## **Addendum # 4**

### **Bid Opportunity: 25-7748-RFT - St. Andrew's Public School 3rd Floor Classroom Refinishing Closing Date: Wednesday, May 21, 2025 2:00 PM**

## Addendum #4

<b>Addendum #:</b>	E-1
--------------------	-----

SHEET NO:  
E-302

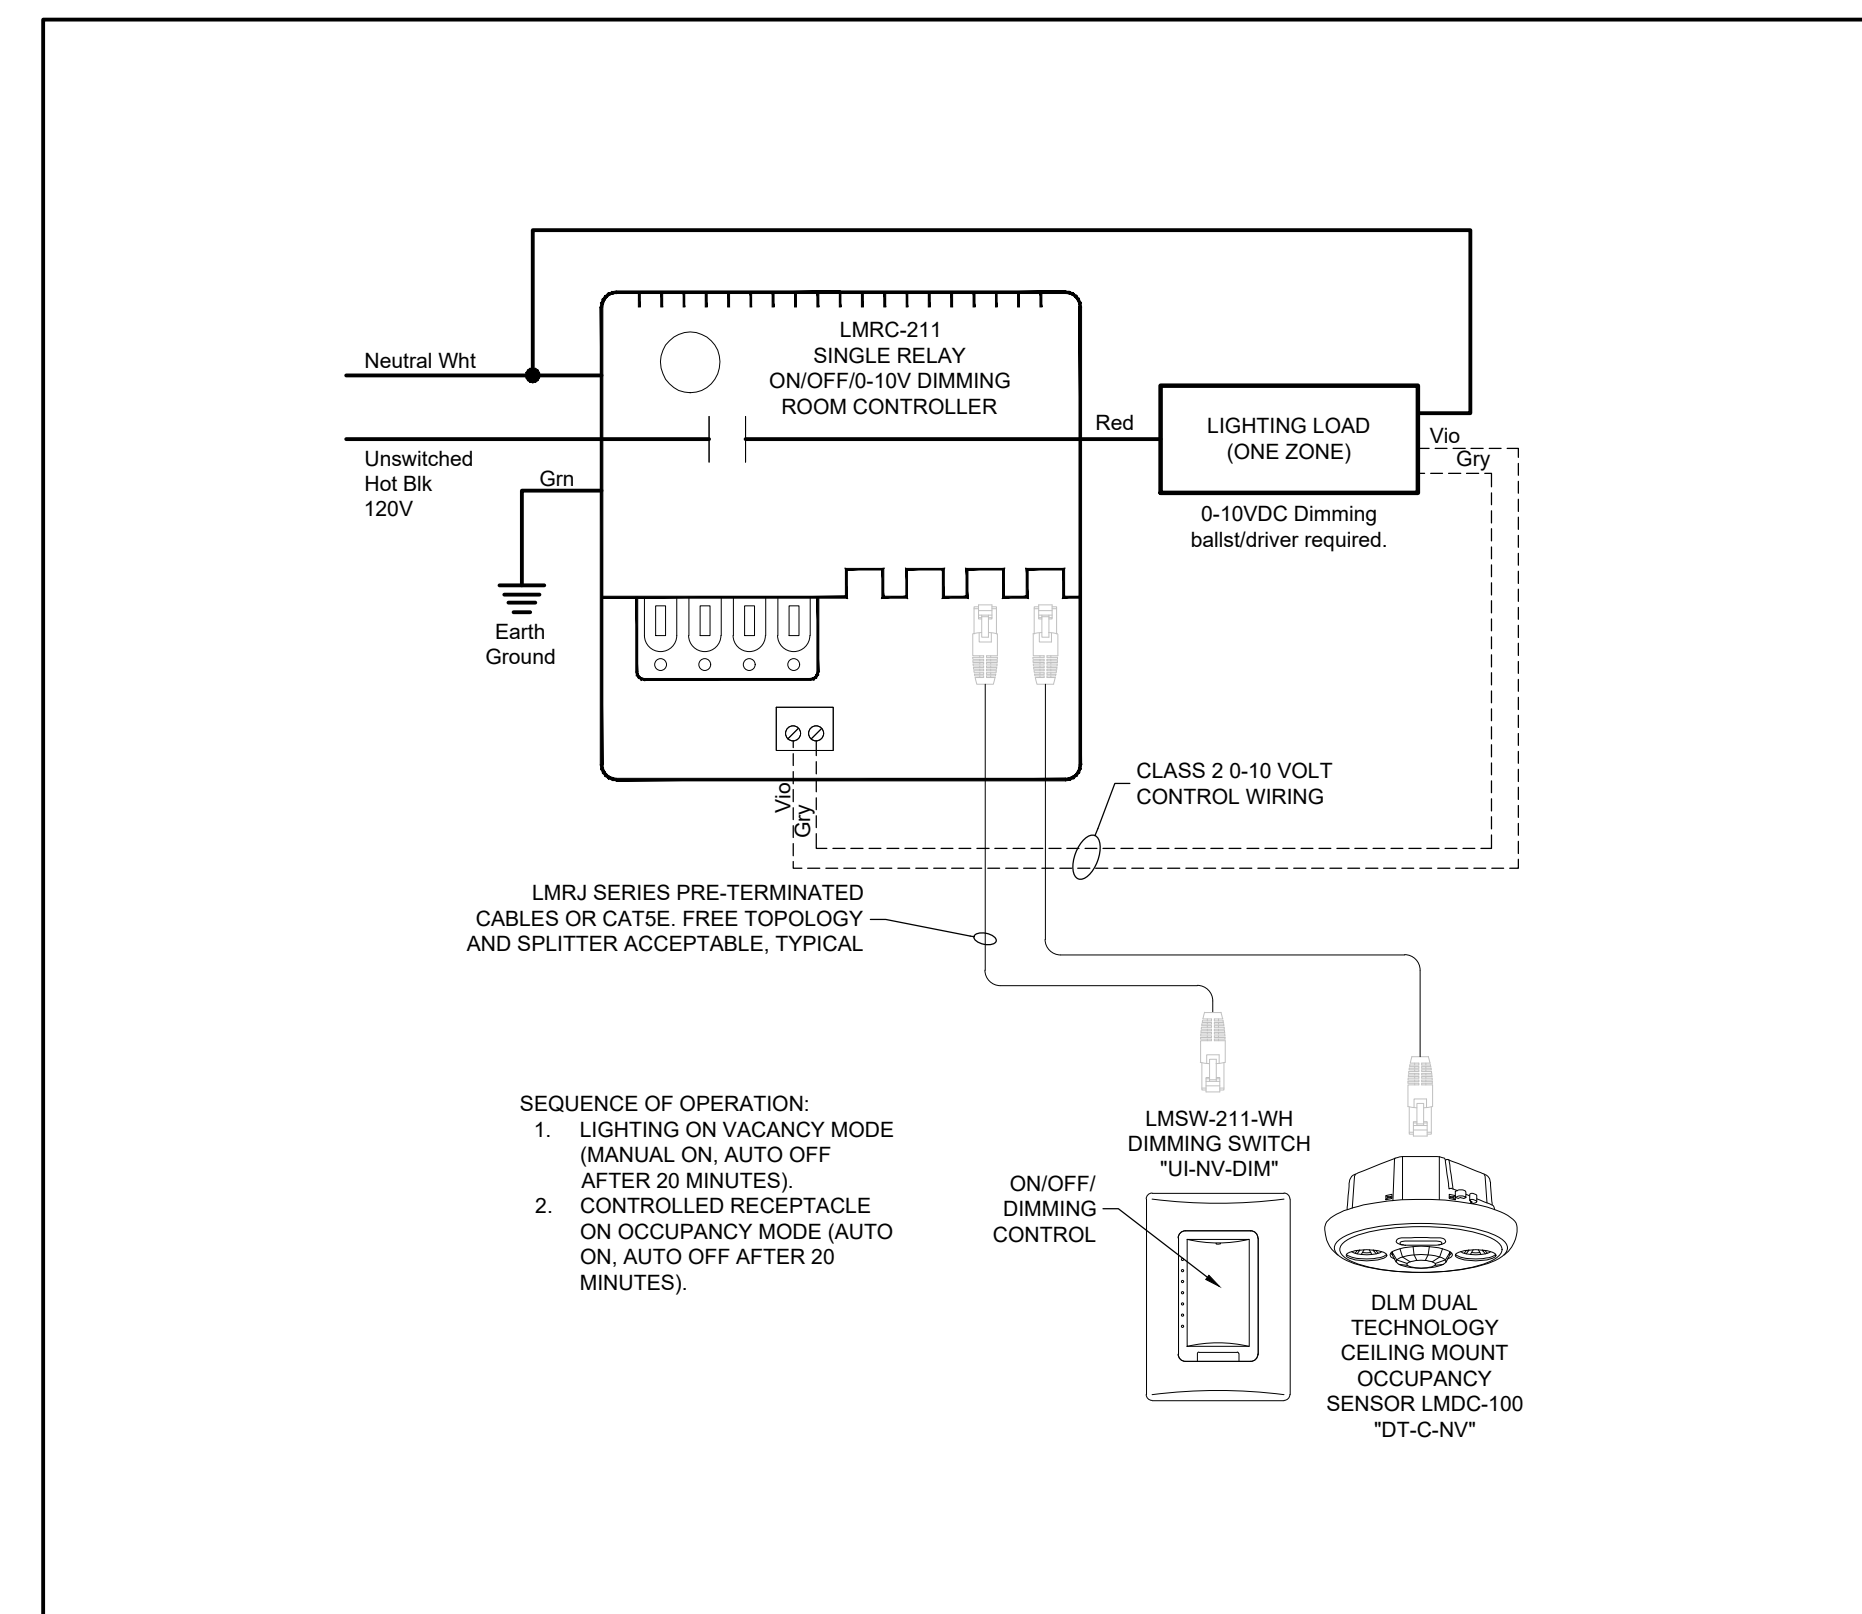
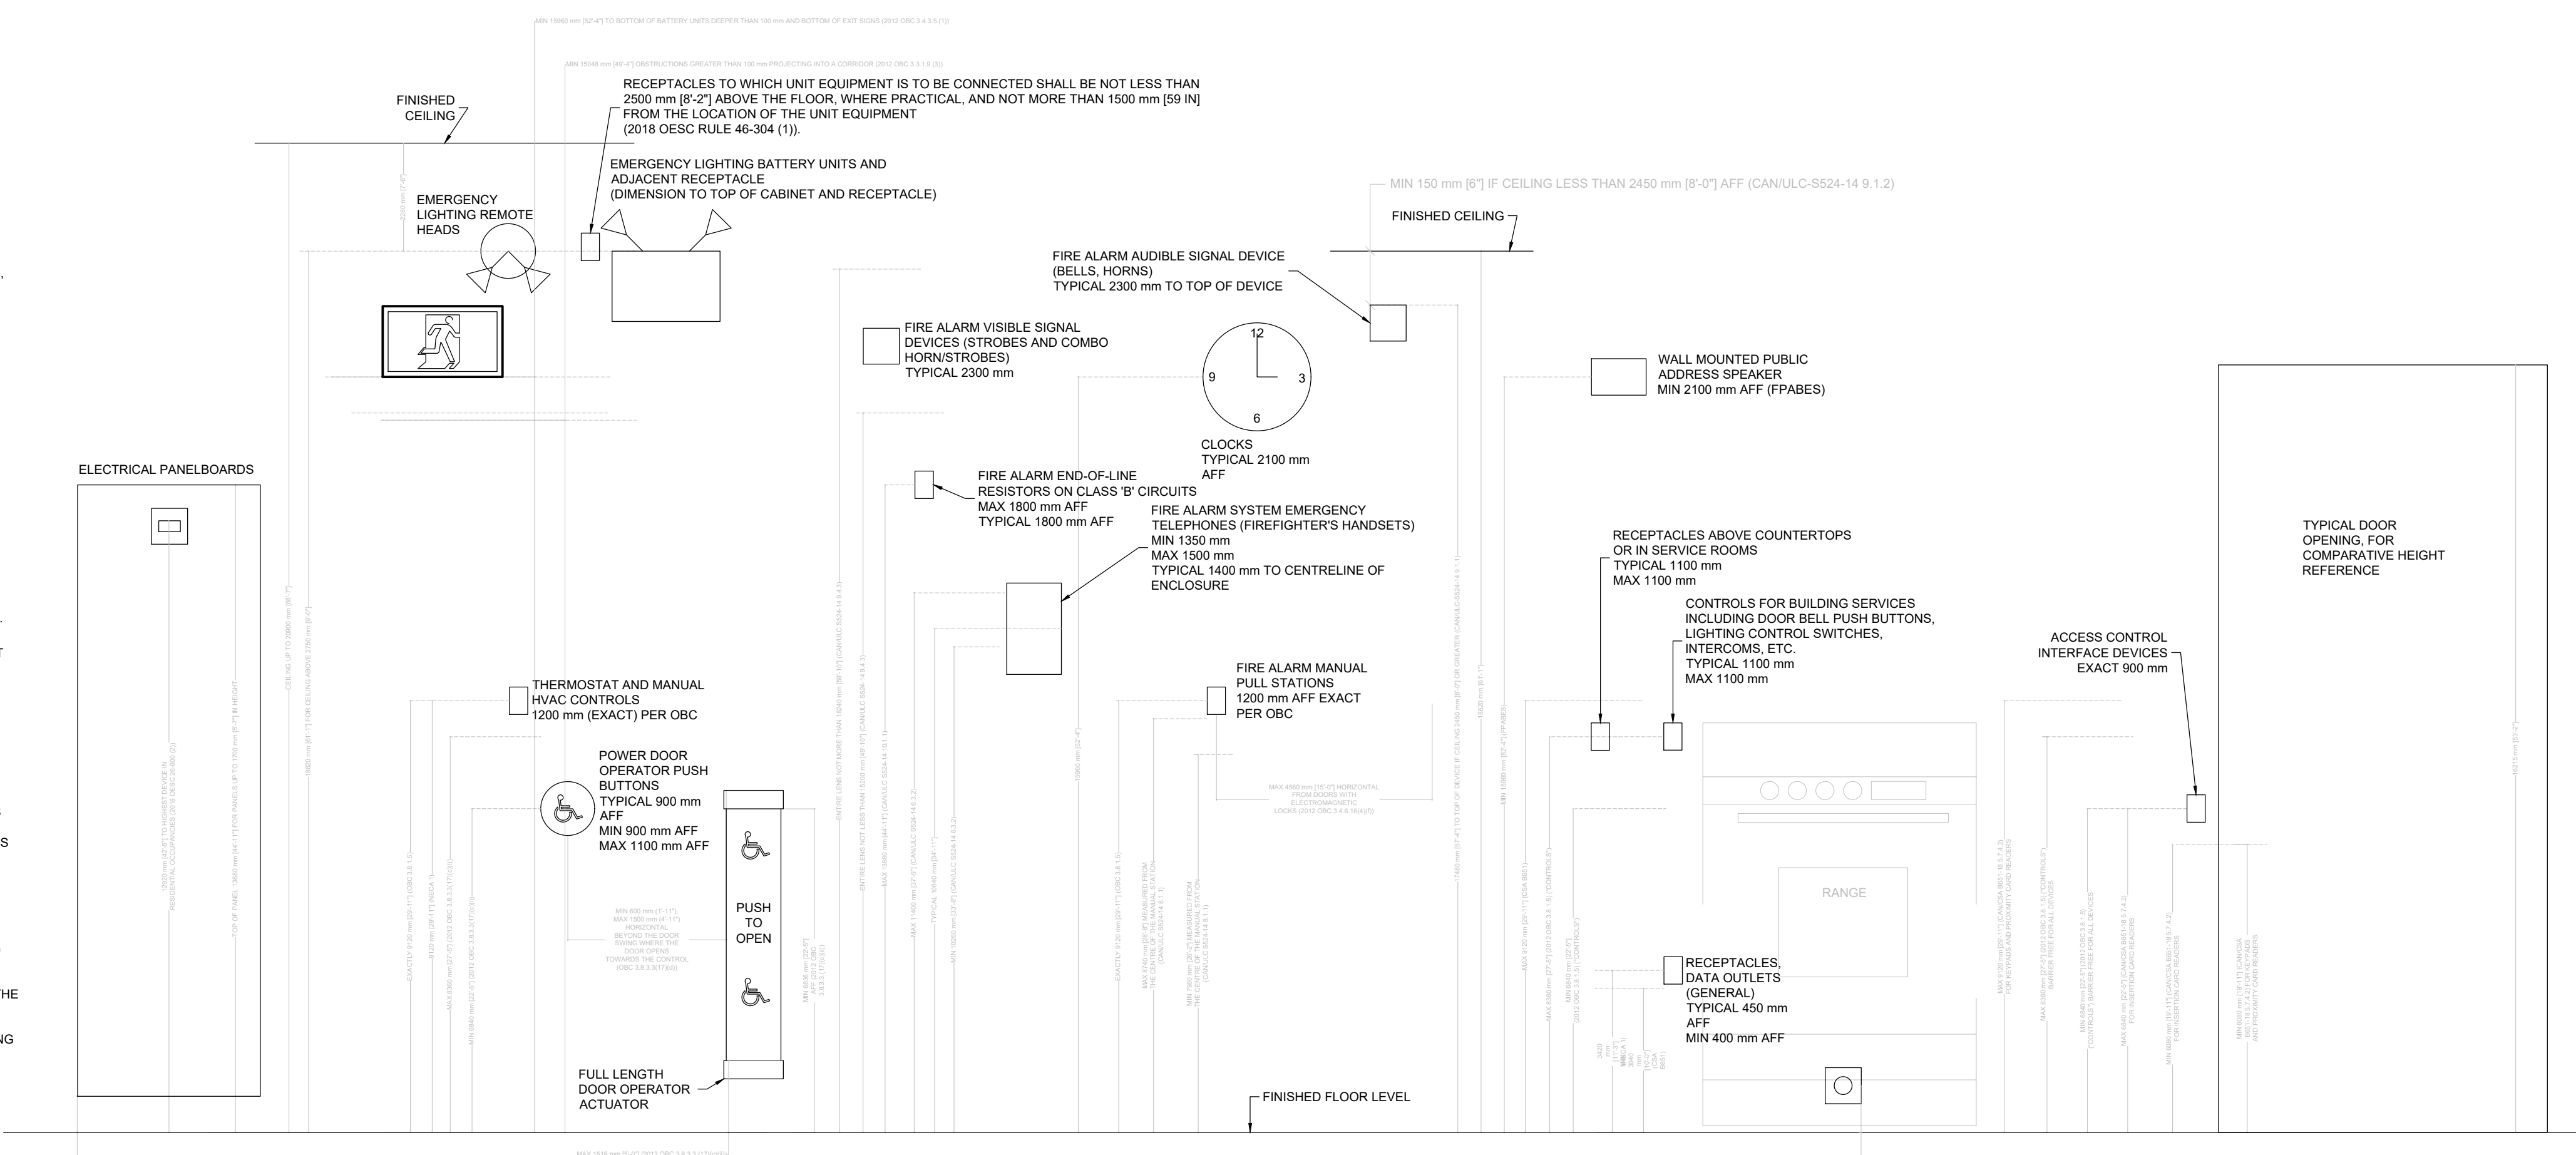
**5. Drawing E-302 – Electrical Detail Sheet No. 2 (Issued herewith):**

- a. Added lighting control details to this drawing.
